Work Order ID 115863

DART SERVICE INSTRUCTION

TO AMEND INSTALLATION INSTRUCTIONS IIN-D205-778 REV. B
AND INSTRUCTIONS FOR CONTINUED AIRWORTHINESS ICA-D205-778 REV. 1

REF TCCA STC: SH08-37

FIGURE 1: RIVET INSTALLATION
 (CUSHIONS NOT SHOWN)

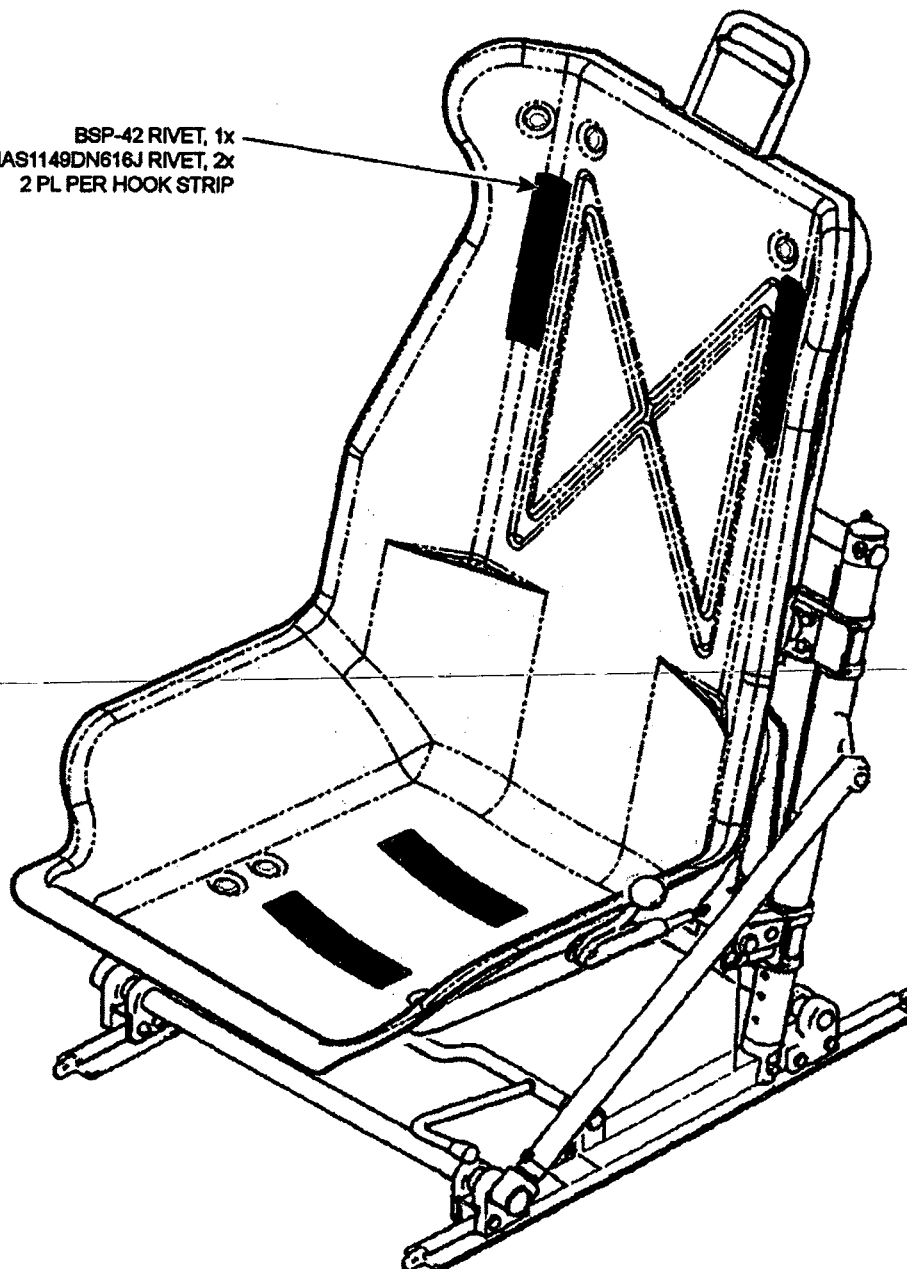
To provide instructions to allow the hook strip (ie. velcro) on the D3752-1 Seat Frame to be fastened with rivets.

D205-778-011 Comfort Seat Kits at CHG 002 have rivets and washers that may be installed to fully secure the D3800-3-200-060 Hook Strip to the D3752-1 Seat Frame. The parts list of Installation Instructions IIN-D205-778 and Instructions for Continued Airworthiness ICA-D205-778 is amended as shown below. Installation of the rivets is optional.

Install the BSP-42 rivets as detailed below, see Figure 1 of this service instruction as reference:

- 1) Ensure location of D3800-3-200-060 Hook Strip lines up with loop strip on seat cushions.
- 2) Drill D3752-1 Seat Frame using 9/64" (Ø0.141) drill in appropriate locations: ensure rivet location will not interfere (contact) with the OEM metal seat frame. Deburr hole.
- 3) Install each BSP-42 rivet with qty(2) NAS1149DN616J washers (one on either side of the plastic seat frame). It is acceptable to substitute longer/shorter BSP rivets or thicker NAS1149DN632J washers to ensure proper fit.

BSP-42 RIVET, 1x
 NAS1149DN616J RIVET, 2x
 2 PL PER HOOK STRIP
